# CHATHAM COUNTY PURCHASING DEPARTMENT

## ADDENDUM NO. 1 TO BID NO. 17-0070-6

### CABLING RENOVATIONS AT THE CHATHAM COUNTY ADMINISTRATIVE / LEGISLATIVE COURTHOUSE

FIRST FLOOR PLAN -  
SCALE 1/8" = 1'-0"

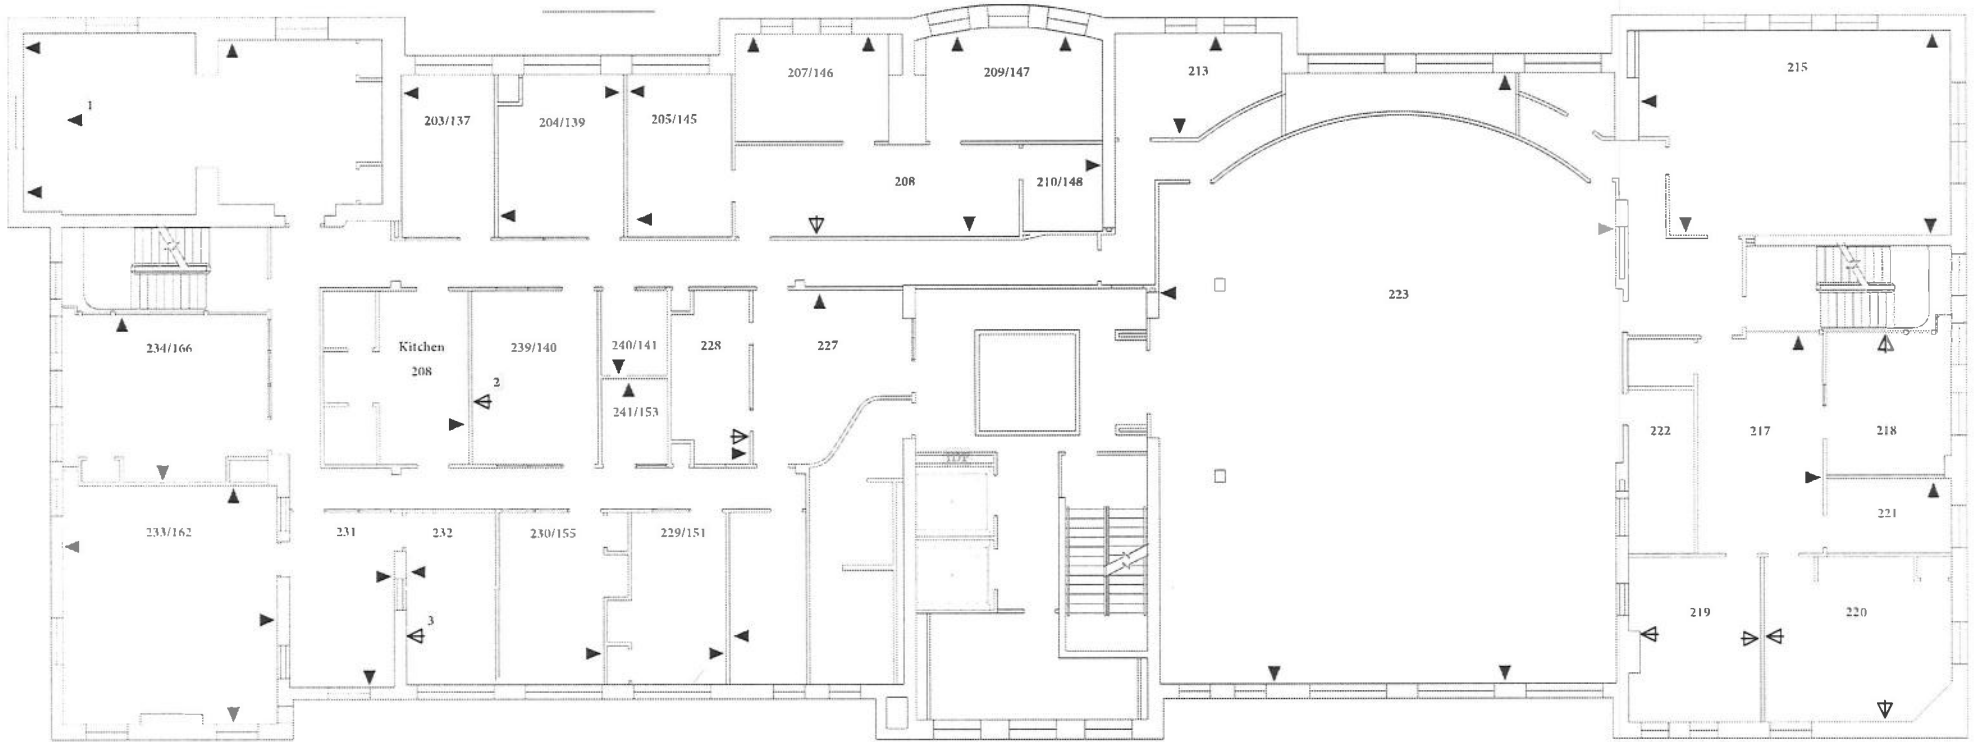
9. See attached *REVISED* floor plan.

1. Floor box located under desk and runs to 1st floor.
2. Add 1 Cat6 outlet to this existing location
3. Add 3 Cat6 outlets to this existing location
